Product improvement: Extended Breaking Capacity Rating

SHF 6.3x32 / SHF 6.3x32 Pigtail					0118.2267	
creation date	created by	release date	released by	notification no.	revision	page
2015-01-22	ruettiha	2015-01-28	ruettiha	26945		1 of 2

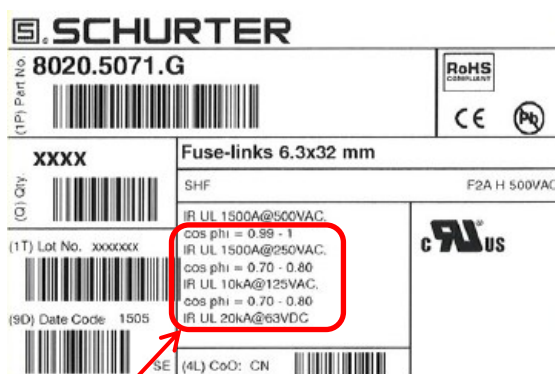
Approval added

Old Label

New Label

Approval added

Interrupting Rating					
AC			DC		
Volts	Amps	Power Factor	Volts	Amps	Time Const.
500 AC	1'500 A	99-100 %	63 DC	20'000 A	<1 ms
250 AC	1'500 A	70-80 %	--	--	--
125 AC	10'000 A	70-80 %	--	--	--
